**TRANSITIONAL PART 3A PROJECT
ASSESSMENT:
3 Murray Rose Avenue, Sydney Olympic
Park (Formerly Building B, 7 Parkview
Drive)
(MP 11_0082)**

Director-General's
Environmental Assessment Report
Section 75I of the
Environmental Planning and Assessment Act 1979

April 2013

Figure 6: Level 1 Floor Plan

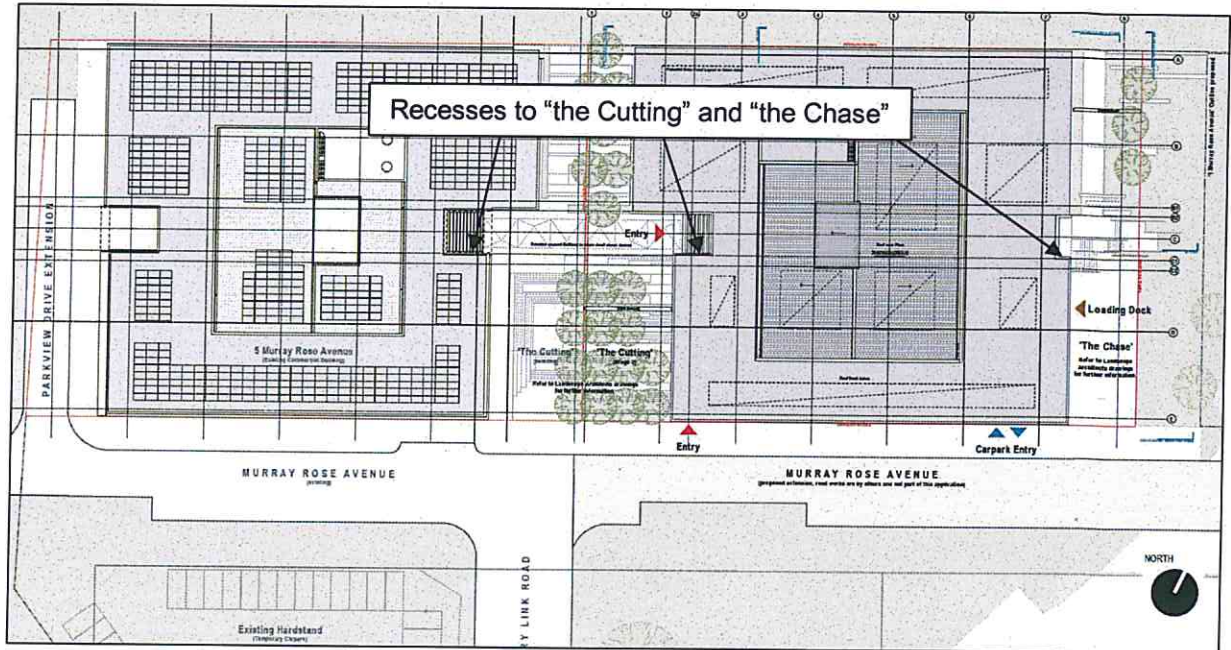
The most notable difference, as noted by SOPA, is that the recesses provided for 3 Murray Rose Avenue are shallower. The proponent contends that:

- the depth of the recess provided to "the Cutting" (see **Figure 6**) is generally consistent with that provided for 5 Murray Rose Avenue, which has been further emphasised in the PPR by extending the south-western corner to the west; and
- the smaller depth of the recess provided to "the Chase" (see **Figure 6**) responds to the context of "the Chase" as a secondary site linkage and the interface with the future residential development and the nature of oblique views to this area.

The department considers that the modulation and design of the recess to “the Cutting” complements the design of 5 Murray Rose Avenue and the recess to “the Chase” achieves modulation of the building into two wings whilst responding to the future context of “the Chase”, as views would be obstructed when the area is fully developed. Accordingly, the department considers the shallower recess is satisfactory. Furthermore, adequate light and amenity is provided to occupants of the building within the vicinity of the recess and the future occupants would not gain any substantial benefit from increasing the size of the recess, which generally complies with 12 metre distance between the core and ancillary services to an external window as recommended in MP 2030.

Figure 9: Landscape plan for “the Chase”

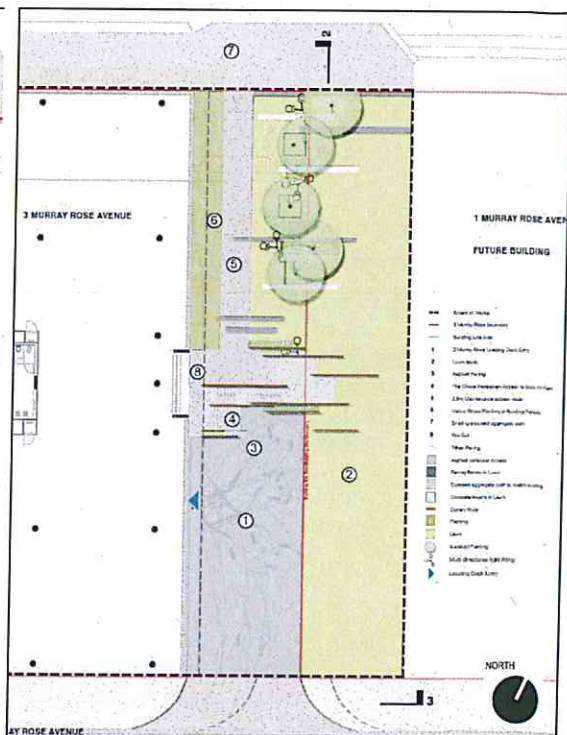
SOPA advised that the width of the path within "the Chase" did not meet SOPA's accessibility requirements and queried whether deep soil zones would be provided to the proposed eucalypt plantings. The proponent indicated in the response to submissions that the path would be provided to address these requirements. The department has included a condition that requires the proponent demonstrate the final design plans for the landscaped areas meet SOPA's accessibility requirements and demonstrate that the deep soil zones are adequate.

The interim works for "the Chase" would ensure that 3 Murray Rose Avenue has appropriate surrounds immediately upon completion, whilst providing flexibility for the future design of 1 Murray Rose Avenue. The interim design incorporates a mix of hard and soft elements, including an area of lawn, eucalypt plantings, paving for pedestrian access and an asphalt vehicle access to the loading dock. The area within 1 Murray Rose Avenue is to be grassed and would provide an appropriate arrangement in the interim as it connects the proposed lawn within the 3 Murray Rose Avenue site and the adjoining vacant grassed areas within 1 Murray Rose Avenue.
